March 7, 2018

Chris Hatton, IGAP
Wrangell Cooperative Association
igapchris.wca@gmail.com

Re: Wrangell Byford Junkyard Cleanup

Figure 3. Proposed monofill sites. From DEC memo, February 2 2018, by Sally Schlichting.

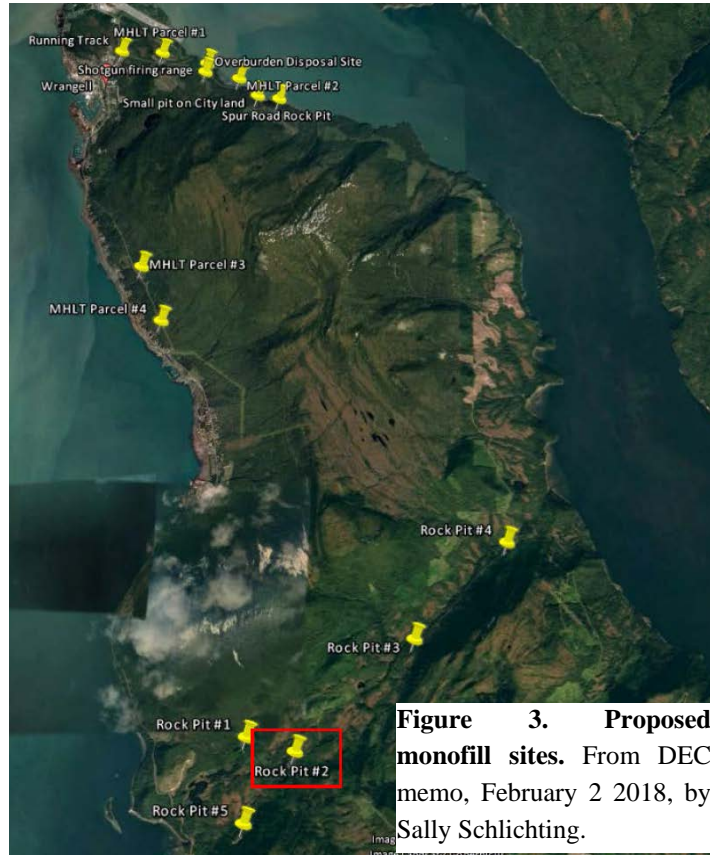
DEC initially inspected 4 locations as potential repositories and settled on DNR Rock Pit #2,¹⁰ apparently suggested as a containment site by DNR,¹¹ 8 miles from town on DNR-owned land. After this, the City and Borough of Wrangell and the Wrangell Cooperative Association suggested other sites. DEC examined 15 sites in all and again placed Rock Pit #2 as their number one choice. The preference for the quarry is due to its location, size, accessibility, and characteristics such as 3 sides with rock walls to contain material.¹²

Sites were not evaluated based on ecological risk, such as proximity to surface water, groundwater, or ecological receptors. Some sites were dismissed based on proximity to homes and schools, but these were dismissed without an actual conceptual model of the exposure pathways or risks. Other sites were dismissed based solely on size or ease of access. There was no logical economic and ecological comparison of sites, or conceptual models that would provide a comparison of environmental risk at sites suggested by the City and Borough of Wrangell and the Wrangell Cooperative Association.

- **Recommendation.** Provide an itemized cost analysis for a select group of potential monofill locations, and include an option for shipping off-island.

Figure 5. Monofill cover & cap designs. (Left) Cover design described in the January 2017 Ahtna Engineering report. (Below) Cover design described in the May and June 2017 E&E reports.

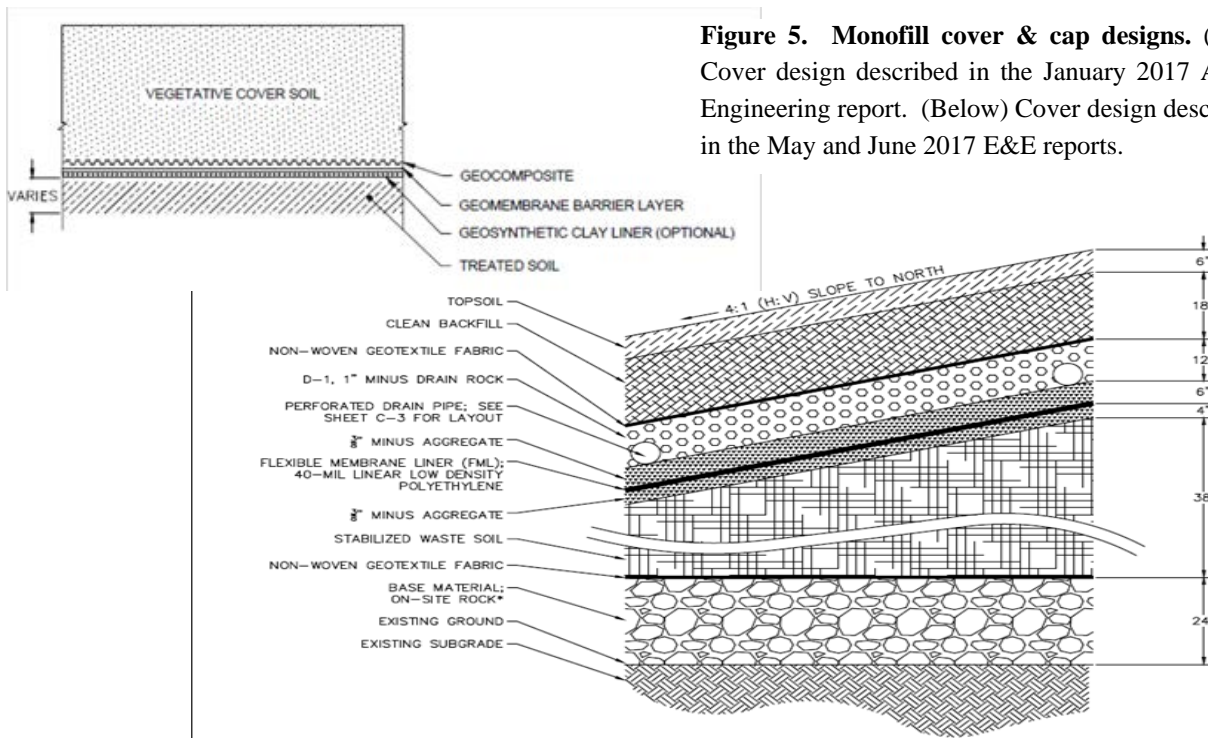
The actual design of the monofill is good, although there is incomplete information on the seepage that each cover design would allow to infiltrate into treated soil. By law, a cover needs to minimize water infiltration.¹⁷ Two cap & cover designs were described:

January 2017 Ahtna report described the cap as consisting, from the soil up, of a geosynthetic clay liner (GCL) covered with a 60 mil HDPE liner, with geotextile above that and topped with two feet of soil that would be vegetated. The clay and HDPE liners limit water from reaching the soil; vegetation acts to prevent erosion and provide evapotranspiration for some of the rain and snow. A detailed infiltration analysis was conducted. The cover with the GCL should only allow about one gallon of surface water per acre per year to infiltrate into the treated soil; however if the

GCL is not used, the infiltration could be around 280 gallons per acre per year. HDPE liners are rolls of material welded together at the seams; they perform best when there are no gaps, tears, or cracks, which in turn require folds and wrinkles in the rolls to be smoothed.

The May 2017 E&E Design report¹⁸ has replaced the geosynthetic clay liner with four inches of 3/8" aggregate, and replaces the 60 mil HDPE with a thinner 40 mil LLDPE barrier. It adds perforated drainage pipe embedded in another layer of 3/8" aggregate and D-1 drain rock. It keeps the upper layer of geotextile and soil with vegetation. The E&E report states that the 40 mil LLDPE barrier "will easily meet" the legal requirements for limiting infiltration¹⁹ but there is no clear table describing seepage rates as there was in the Ahtna report. The detailed infiltration analysis appears to have been done for uncovered soil with a result of 780 gallons per acre infiltrating per *day*, or 72,200 gallons per acre per year. The attachment with outputs of the infiltration model was not accompanied by a clear table of results that the layman could understand.

Two covers were discussed in documents. Essentially DEC appears to have replaced the GCL barrier of the 2017 Ahtna report with a drainage pipe and the HDPE barrier with a more flexible LLDPE barrier that is less susceptible to cracks and tears. However, it was the GCL barrier that really kept rainwater from infiltrating into the soil pile. I would think that the GCL layer tied into chimney rock would provide sufficient drainage, and do a better job of keeping water away from the treated soil. If drainage pipe provides an advantage, what would be the cost of placing both drainage pipe and GCL within the cover?

- **Recommendation.** Based on percent soil moisture and soil volume, provide information on the volume of soil porewater that could drain down after a cover is in place. Combine this information with contaminant analysis to provide a clear description of soil contaminant types and concentrations in porewater.
- **Recommendation.** Provide a simple itemized comparison of the amount of water and seepage rates that each design will allow to infiltrate into soil along with an itemized comparison of the costs.

Figure 7. Monofill drainage design. From E&E 2017.

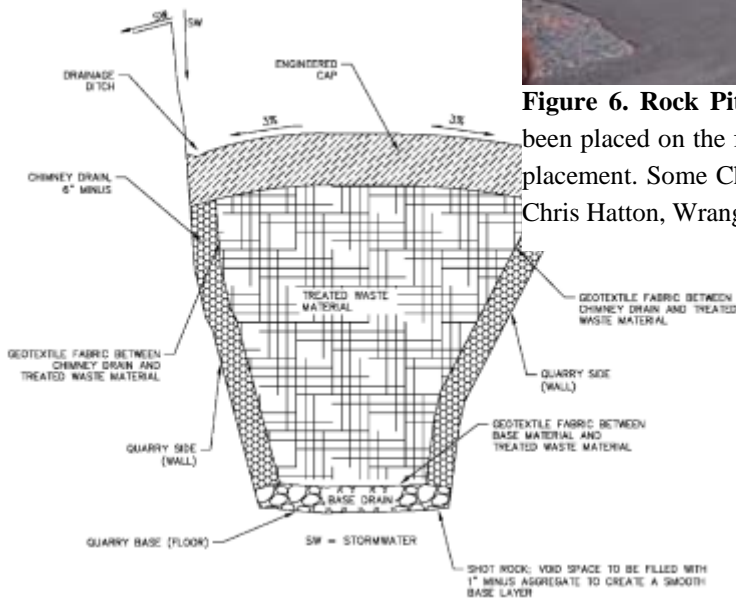
The design does not include a liner or a liner/leachate system. The cost for such a system is minimal, about \$135,000.²² The reasons for not incorporating this in the design were that a liner would collect water and be subject to freeze-thaw action that could cause cracking and leakage, and a liner/leachate system would require thousands of feet of pipe to collect the leachate. The design without the liner/leachate system was expected to allow

water quality sampling at the location where the chimney drain/French drain system discharges, and groundwater could be sampled at the monitoring well at the head of the quarry. The location and design of the discharge outlet was not available in the E&E Basis of Design report but a drawing was available in the 2017 Nortech report (see attachment 2), along with some photos.

The monofill is designed to direct stormwater runoff off the cover into a French drain that would split, with drainage apparently discharging near the mouth of the quarry and through a culvert on the opposite side of Pat’s Creek Road.²⁵ This information is provided in a single figure in the Monofill Baseline Sampling report; site inspection and Basis of Design drawings provide no information on the final outfall for drainage. There is no estimate of the monthly or seasonal drainage flow at the outfall in any documents I reviewed.

- **Recommendation.** Provide mitigation options to control, treat, or divert seepage if contaminant levels increase at testing locations.
